# **CAMINO REAL REGIONAL MOBILITY AUTHORITY BOARD RESOLUTION**

**WHEREAS**, the Camino Real Regional Mobility Authority (CRRMA) entered into a Construction Agreement dated October 15, 2015 (Agreement) with Paso del Norte Trackworks for the construction of the infrastructure component of the El Paso Streetcar Project being developed by the CRRMA;

## El Paso Streetcar Infrastructure Project

**CONSTRUCTION CONTRACT CHANGE ORDER NUMBER: 0014.00**

MSF - ON DOOR/BEAM  
2.15.2017

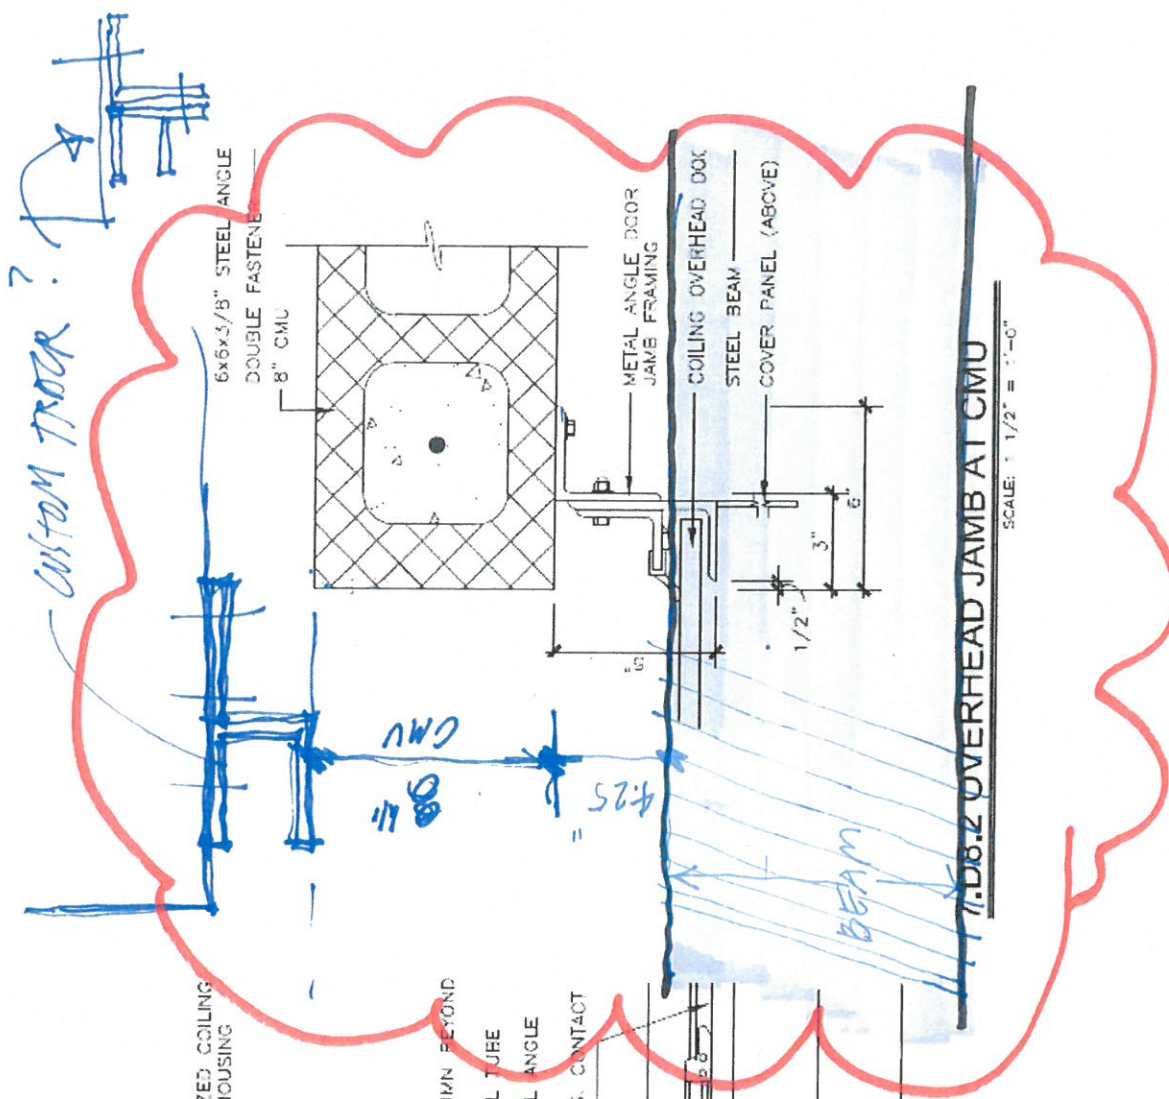
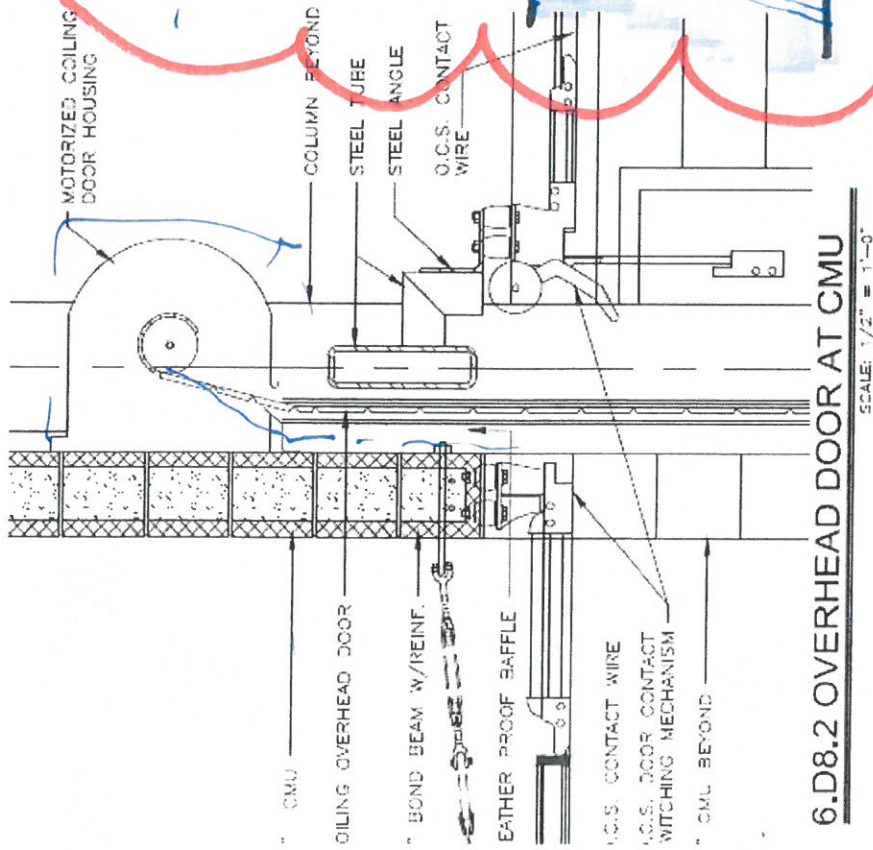
Mezzanine, I beam and CMU wall are in conflict to install scheduled roll up door and guide rails at work area 211, grid lines C, 5-6. Below are available options for the conflict.

1. Install the door on the exterior of the opening. There is a cost associated with this option for an exterior motor cover.
2. Modify and install the existing door at the top portion of the opening and provide a smaller door at the bottom which is addressed in options 3 & 4 below.
3. Providing a new 10'8" x 6'8" door/ motor and installing it to the existing frame resulting in an additional cost. Additional electrical will be required for the motor.
4. Providing a new 10'8" x 8'4" door/ motor resulting in an additional cost. Additional electrical will be required for the motor. Re-frame the opening to increase the door height will be required.

NOTE: CLEARANCE MASONRY FACE TO BEAM FLANGE IS 4.25".  
CAN A CUSTOM TRACK BE FABRICATED TO ACCOMMODATE DOOR?

CUSTOM TRACK?

Proposed detail (attached) was transmitted to OH Door Mfg. for review and consideration. They have stated that this detail will work. Final coordination is occurring with General Contractor.
